**DOCUMENT 00 90 00  
ADDENDUM**

**ADDENDUM NO. [2]                      Date: November 8, 2018**

**RE:                      GLENWOOD COMMUNITY SCHOOL DISTRICT  
ATHLETIC COMPLEX IMPROVEMENTS BID PACKAGE 2 REBID  
400 SIVERS ROAD  
GLENWOOD, IOWA 51534  
HSR PROJECT NO. 18005**

**P104R**

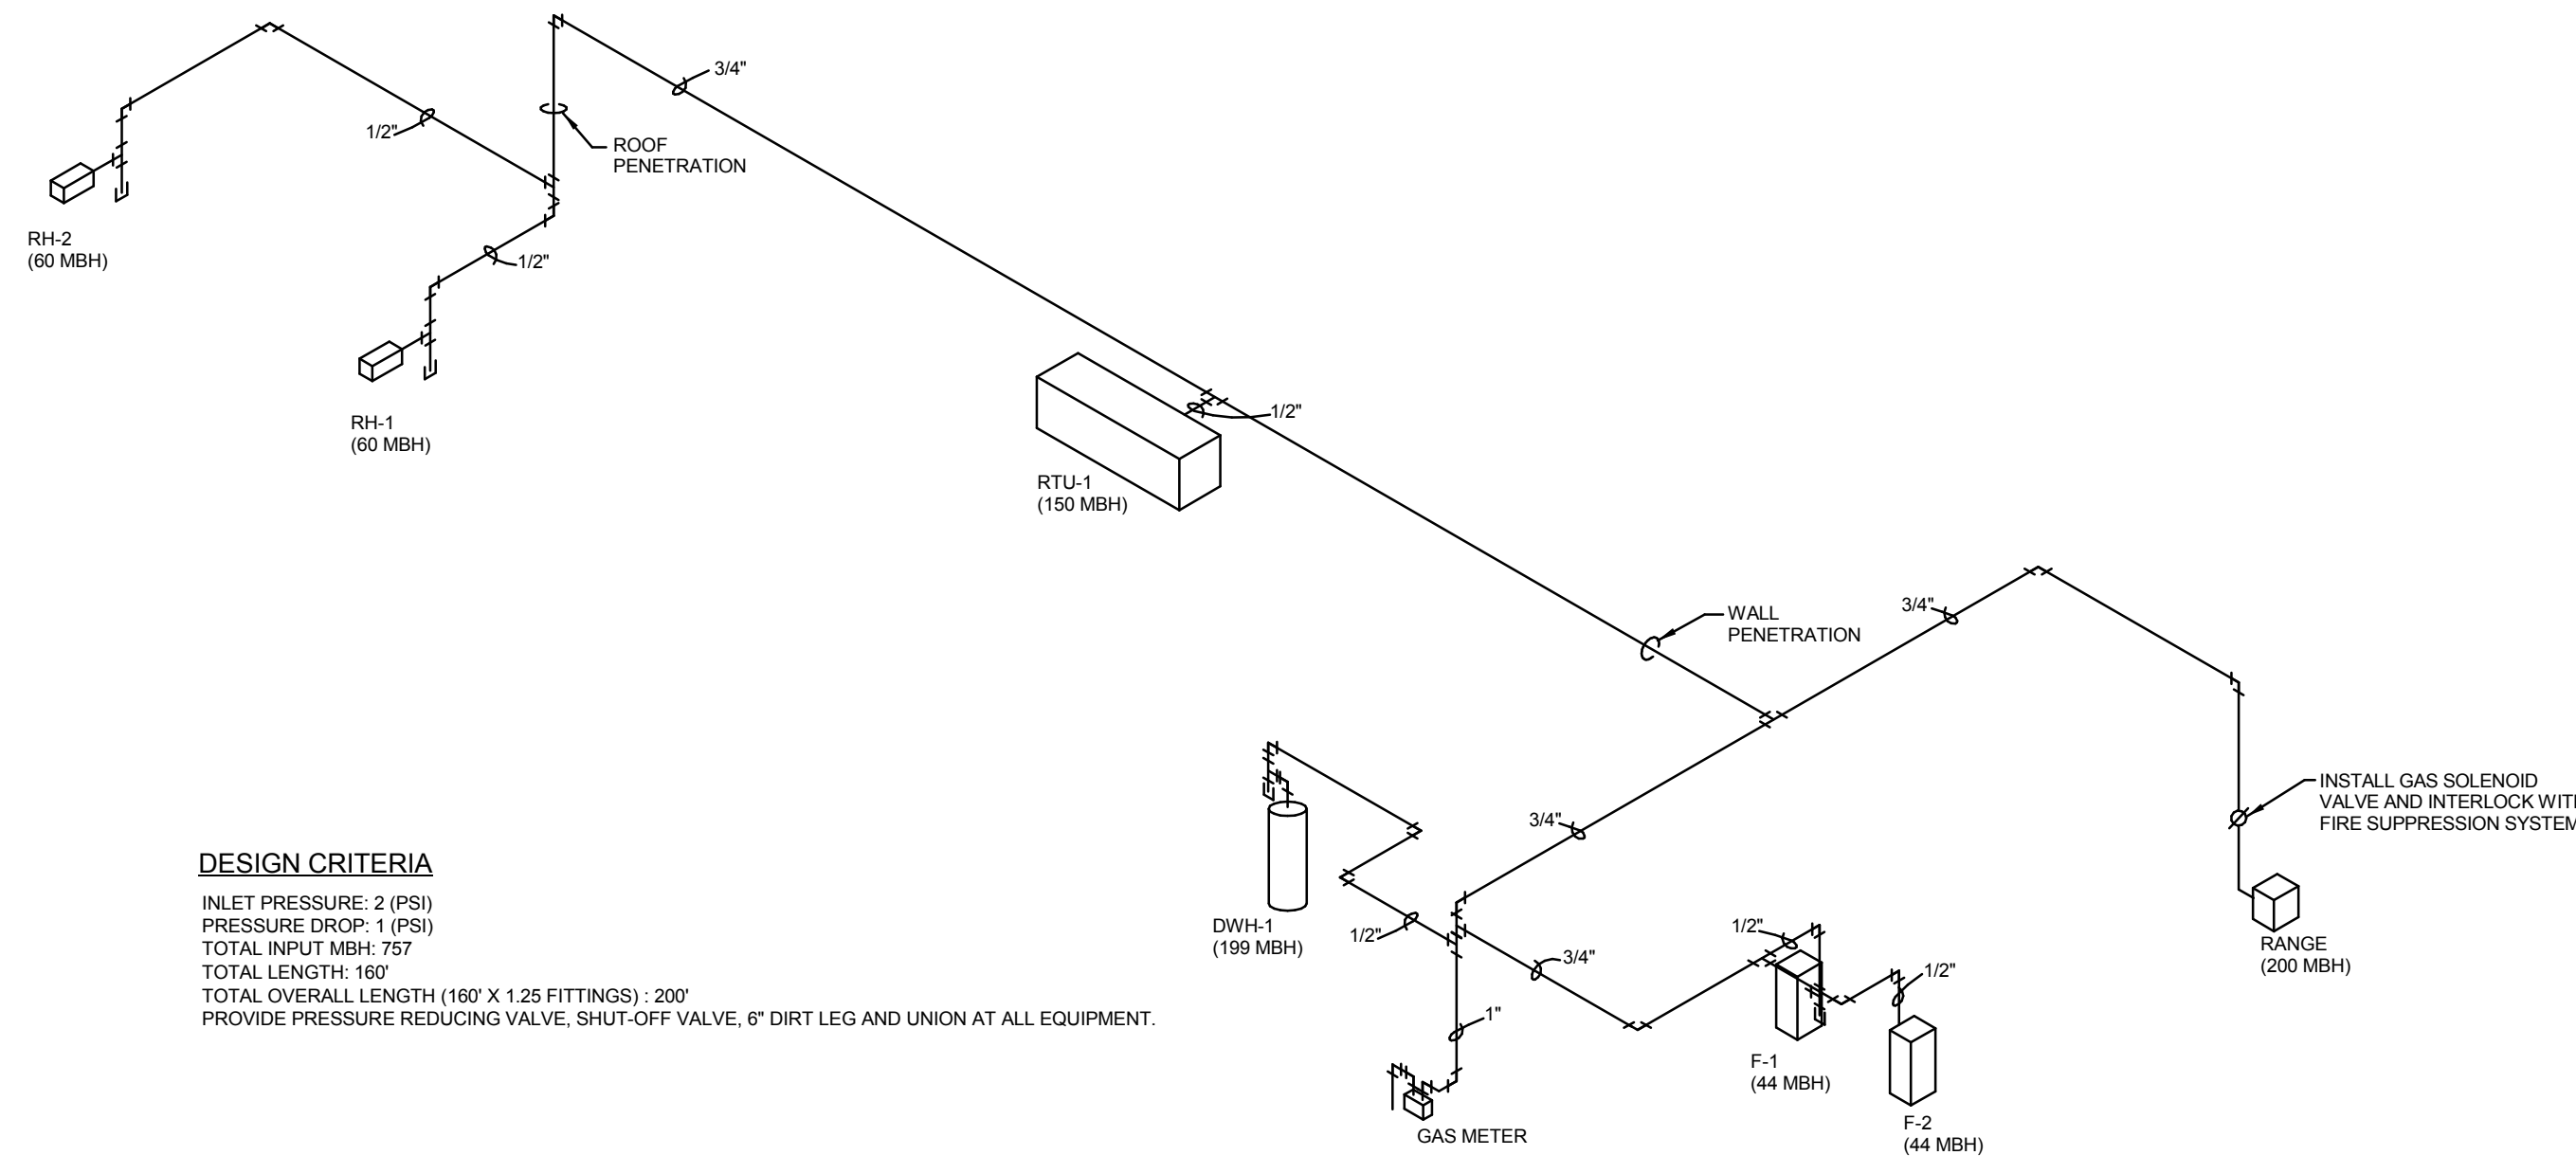
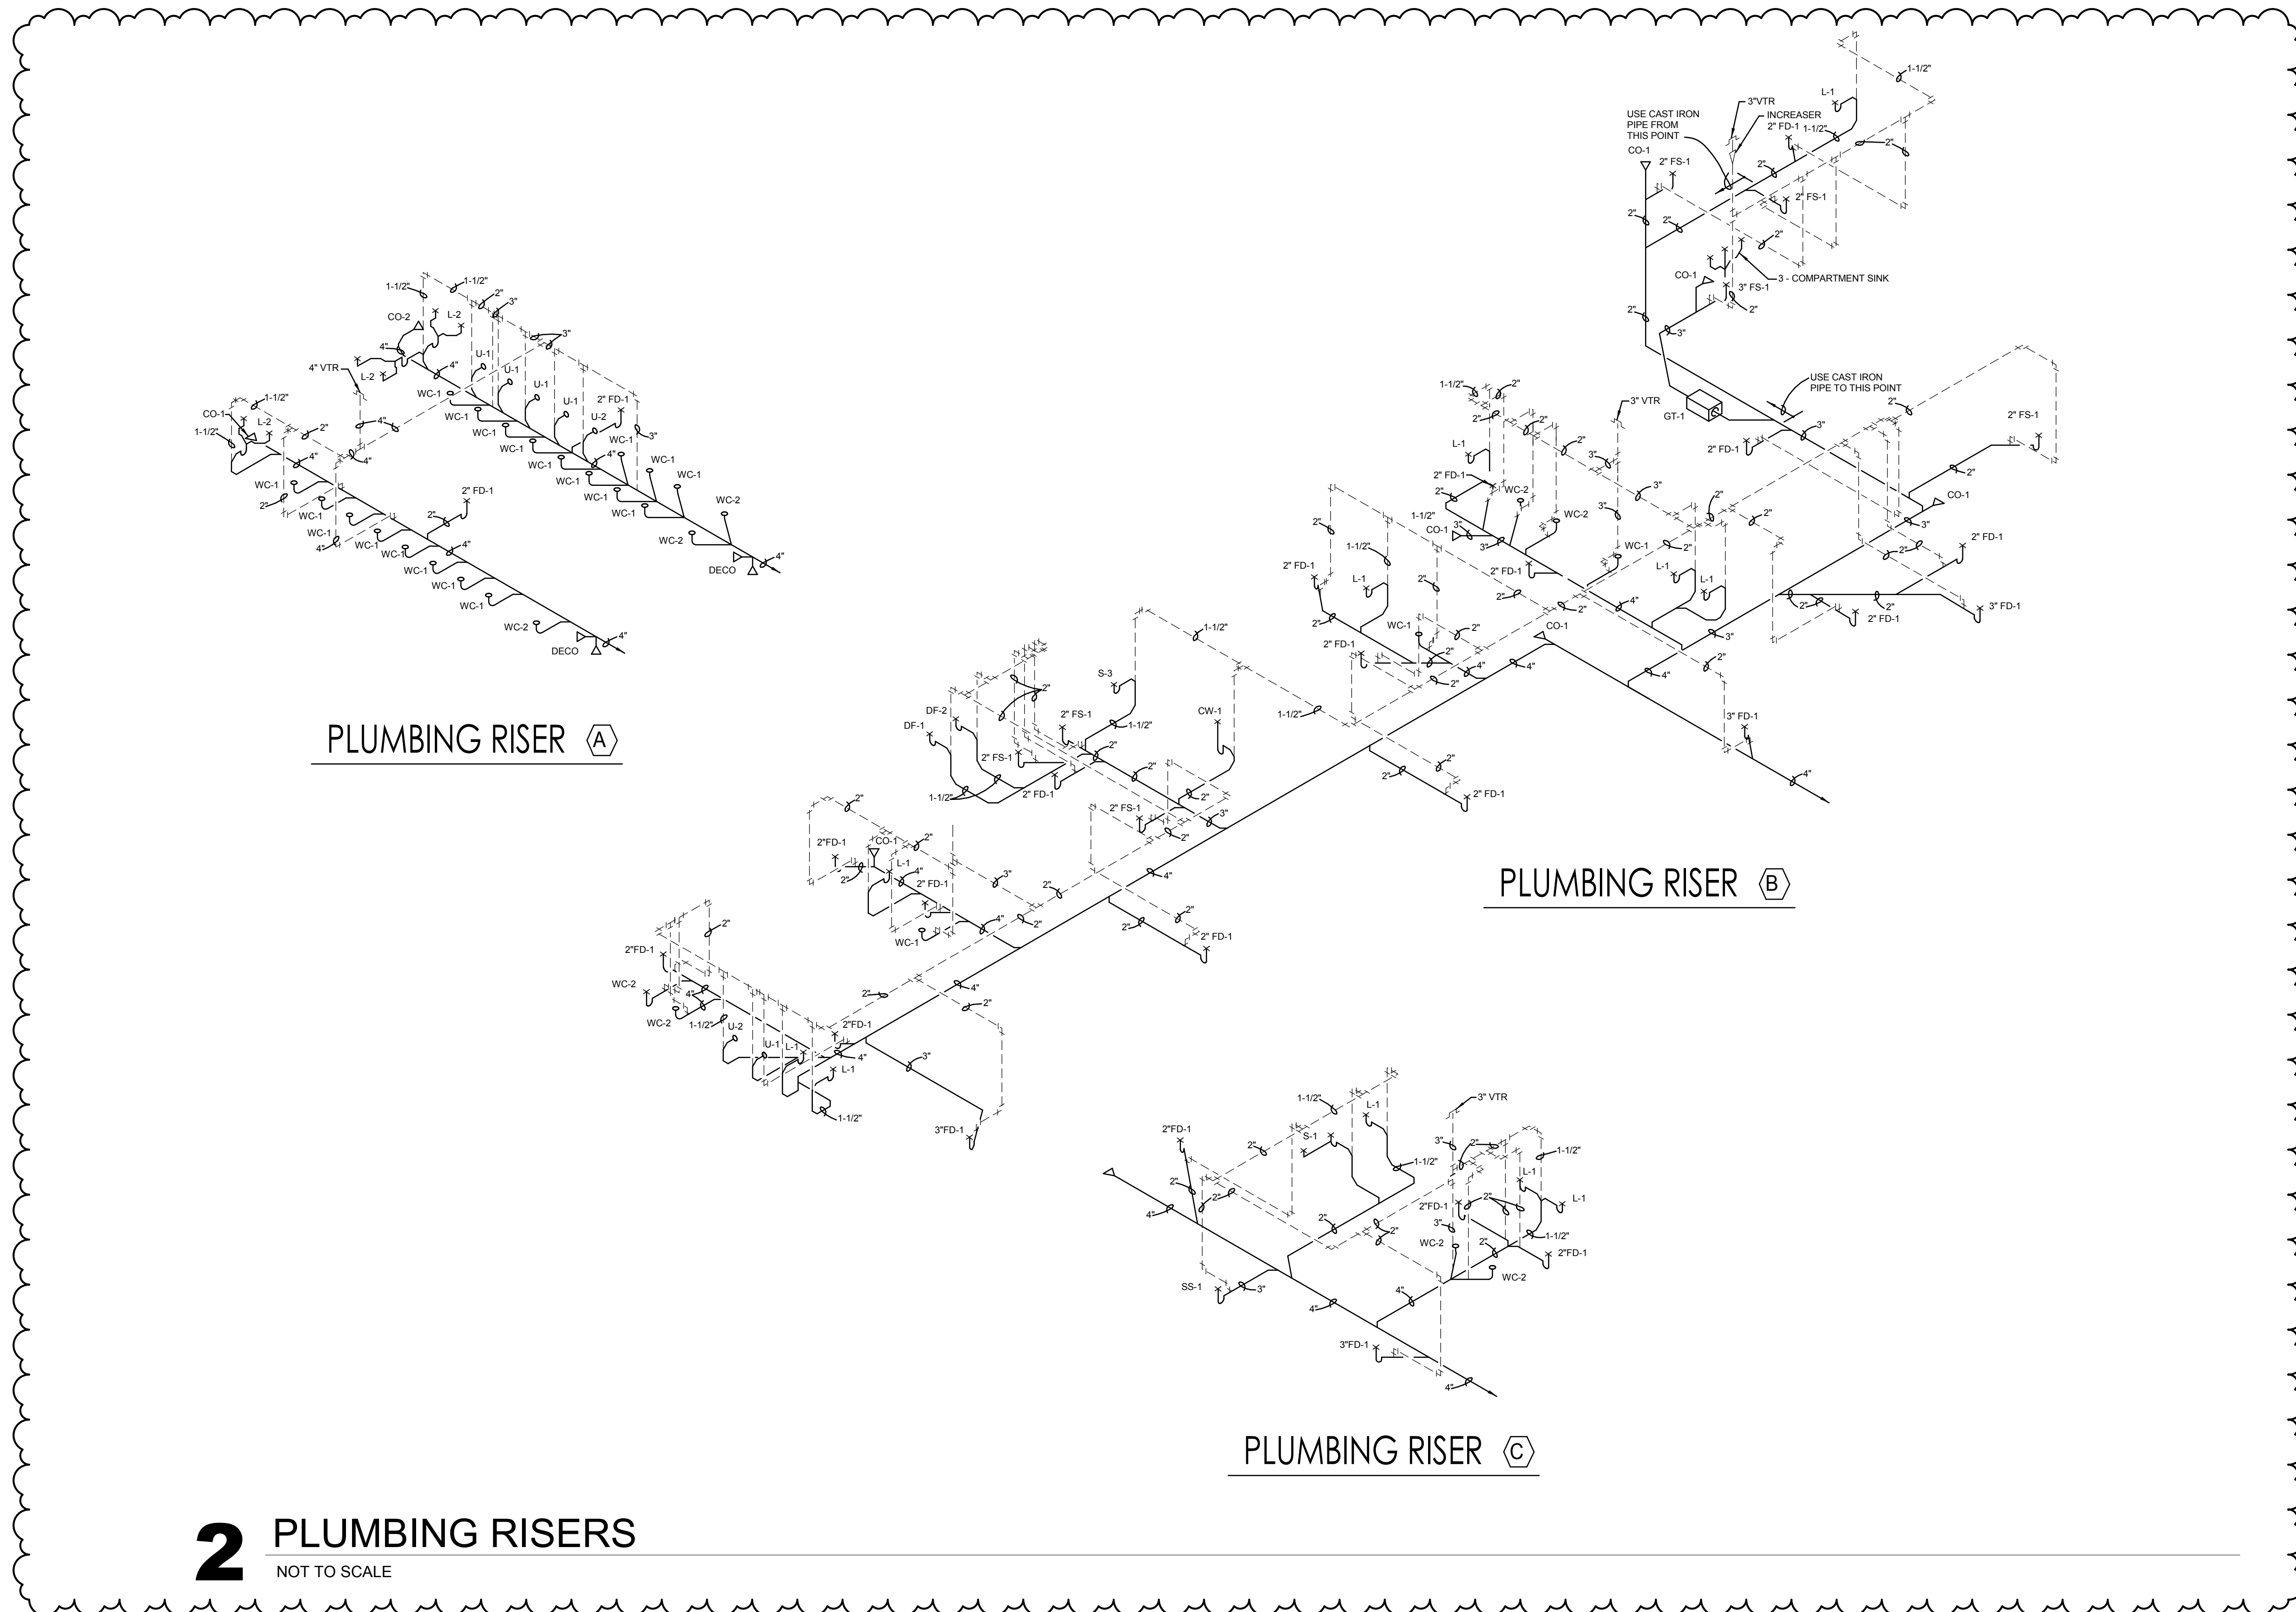
5. Sheet A101R FIRST FLOOR STADIUM PLAN 30 x 42 Drawing attached hereto
  - a. Revisions clouded on Drawing.
6. Sheet A302R FIRST FLOOR STADIUM BUILDING SECTIONS 30 x 42 Drawing attached hereto
  - a. Revisions clouded on Drawing.
7. Sheet P104R PLUMBING AND GAS RISERS 30 x 42 Drawing attached hereto
  - a. Revisions clouded on Drawing.
8. Sheet E101R FIRST FLOOR STADIUM LIGHTING PLAN 30 x 42 Drawing attached hereto
  - a. Revisions clouded on Drawing.
9. Sheet E102R SECOND FLOOR PRESS BOX LIGHTING PLAN 30 x 42 Drawing attached hereto
  - a. Revisions clouded on Drawing.
